PRODUCT BULLETIN

Bulletin No: PB332

Improved Board Holder for FR-1012B

FR1012B-01,FR1012B-02

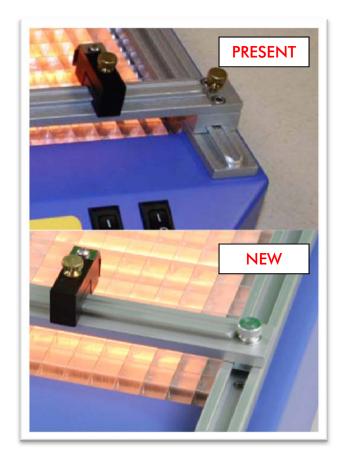
The HAKKO FR-1012B IR Preheater has been improved by upgrading the Y-axis rails of the board holder to the current rail type used by the HAKKO FR-870 IR Preheater. This rail system provide for smoother movement of the rails when adjusting the board holder to fit your PCB.

There is no change to the performance or operating specifications of the product as a result of this change.

NOTE: The new board holders are NOT compatible with older extended Y-axis (PN: 999-225) and additional Clip Rail (PN: 999-226) assemblies from older FR-1012 and FR-1012B units.
